Access Compliance Report

Public Rights-of-Way

Intersection ID: 53964	Main Street: SPRING_SPRUCE_LN	Cross Street: MAGNOLIA_LILY_AV	Location: NW
ADA ID: C44D07374806	Ramp Type: Perp	Initial Pass/Fail: Fail	Overall Compliance: No
		Severity Score: 10

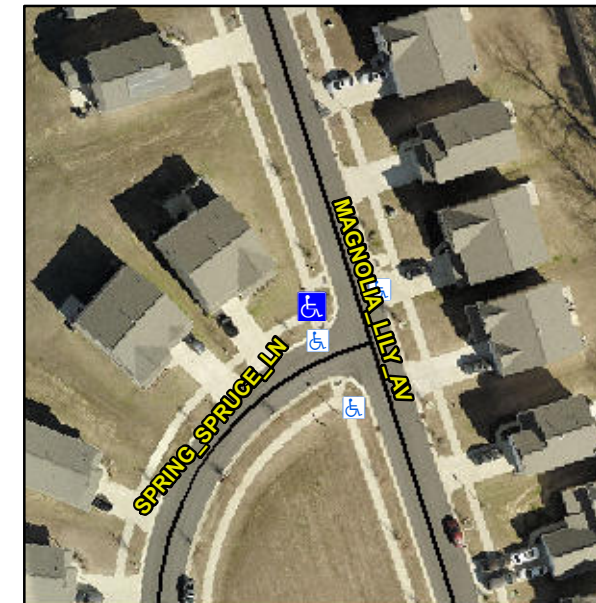
Not Found, R304.5.1

Compliance	Description	Data	Compliance	Description	Data
N/A	Ramp Length (in)	95.0	Yes	Ramp Slope (%)	7.6
No	Ramp Width (in)	47.0	Yes	Ramp XSlope (%)	2.2
N/A	Flare Type LT	N/A	N/A	Flare Type RT	N/A
N/A	Flare Slope LT (%)	N/A	N/A	Flare Slope RT (%)	N/A
N/A	Flare Traversable LT?	N/A	N/A	Flare Traversable RT?	N/A
N/A	Landing Length (in)	N/A	N/A	DWS Provided?	N/A
N/A	Landing Width (in)	N/A	N/A	DWS Contrast?	N/A
N/A	Landing Slope (%)	N/A	N/A	DWS Length (in)	N/A
N/A	Landing X Slope (%)	N/A	N/A	DWS Full Width?	N/A
N/A	Landing Curb? (Y/N)	N/A	N/A	DWS Offset (in)	N/A
N/A	Shared Landing?	N/A			
N/A	Gutter Ponding?	N/A	N/A	Gutter Slope (%)	N/A
N/A	Gutter Lip Ht (in)	1.5	N/A	Gutter X Slope (%)	N/A
N/A	Painted X Walk1?	No	N/A	Painted X Walk2?	N/A
	X Walk 1 Direction	To E		X Walk 2 Direction	N/A
N/A	X Walk 1 Width (in)	N/A	N/A	X Walk 2 Width (in)	N/A
	X Walk 1 Slope (%)	2.9		X Walk 2 Slope (%)	N/A
	X Walk 1 X Slope (%)	4.2		X Walk 2 X Slope (%)	N/A

Remove & Replace Entire Ramp.
